**SUBJECT: Request for Proposal / RFP #142F-20 / Midlife Overhaul of 60 New Flyer Forty-Foot Hybrid Buses**

**Addendum No. 5**

**MBTA**  
**RFP 142F-20 / Technical Specification VE20-051**

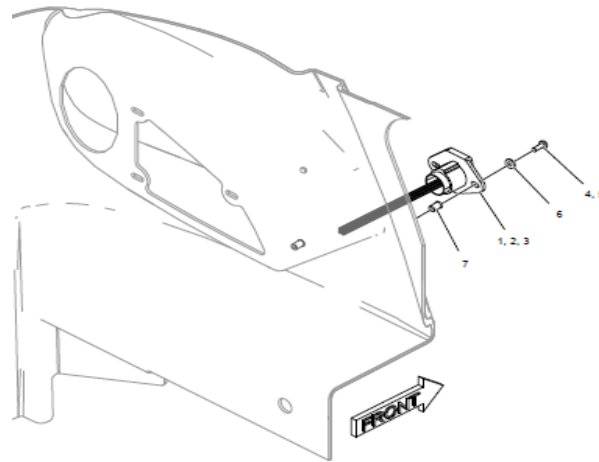
*The first paragraph of Section 3.12.4. provides: The Contractor shall replace tow connector air fittings (per MBTA configuration).*

*The second paragraph adds: “The Contractor shall install a front electrical tow connector similar to the installation on the Authority’s newer fleets utilizing existing vehicle harness.”*

*Please clarify the MBTA configuration for tow connector air fittings and front electrical tow connector*

Please reference the Parts Manual for the SR1983 bus fleet. This attachment was provided in Addendum No. 4. See excerpt below. The Bidders proposed design / solution for TS Section 3.12.4 will be reviewed as part of the design review process.
